July 20, 2011

Re: Tillamook US 101/OR 6 Project – Revised Build Alternative Design
Project Key #14313 – Federal Aid #S009(354)

Figure 1

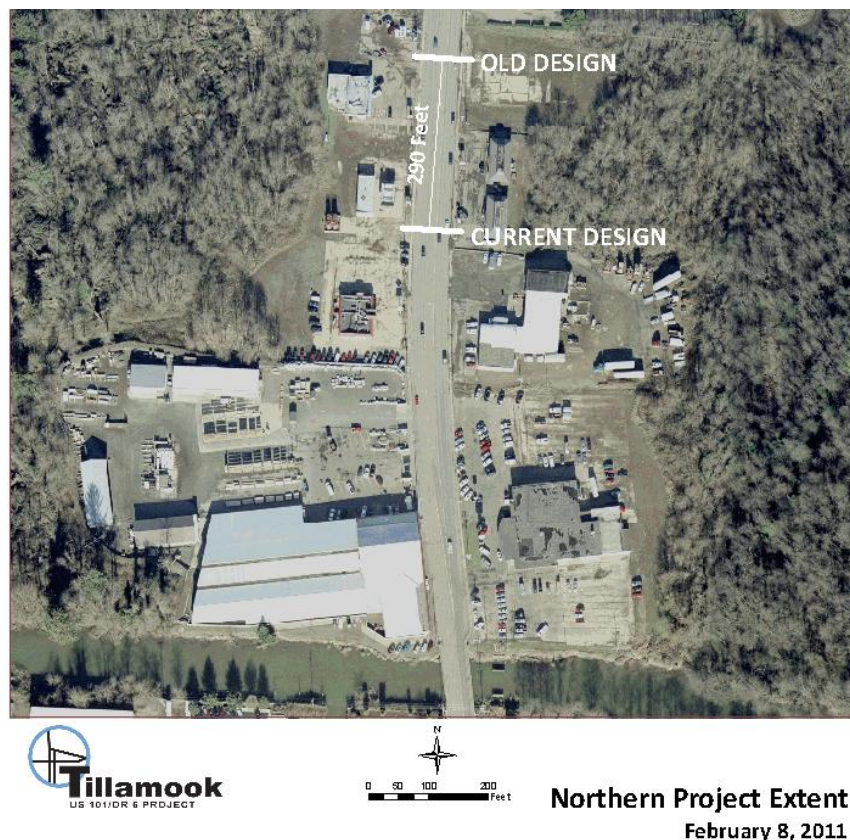
Figure 1 illustrates the Build Alternative to be studied further in the EA. The design of the Build Alternative recently selected by ODOT is similar to what was termed Alternative 2 – Extend Pacific Avenue in the Project Initiation Letter.

- Under the Build Alternative, the existing US 101 bridge over Hoquarten Slough would be removed and replaced with a new four-lane bridge (two lanes in each direction). Alternative 2

would have retained the existing bridge and converted it to two lanes in the southbound direction and would have constructed a new bridge for two northbound lanes.

- Compared to Alternative 2, the Build Alternative would have an eastbound to northbound left-turn lane on 1st Street at Pacific Avenue and would have a southbound to westbound right-turn lane on Main Avenue at 1st Street. The additional turn lanes and other related modifications would improve traffic operations at those intersections (i.e., improved volume-to-capacity ratios [v/c]).

- The design of the proposed bridge evolved from a clear span across the Hoquarten Slough under Alternative 2 to a two-span bridge with a single set of piers in the slough under the Build Alternative. With the design change, the depth the bridge deck was reduced from approximately seven feet to approximately three feet, which would lower the elevation of the top of the bridge deck by approximately three feet. With a lower bridge deck elevation the northern terminus of the project would be reduced by approximately 290 feet (see Figure 2) and the extent and height of new retaining walls adjacent to US 101 north and south of the slough would be reduced.

- Under the Build Alternative, the width of the proposed right-of-way for US 101 at Hoquarten Interpretive Trail Park would be reduced by approximately 10 feet (by eliminating the need for clearance between the existing and new bridge spans under Alternative 2). As a result, the Build Alternative would use slightly less of park property for roadway right-of-way, compared to Alternative 2.
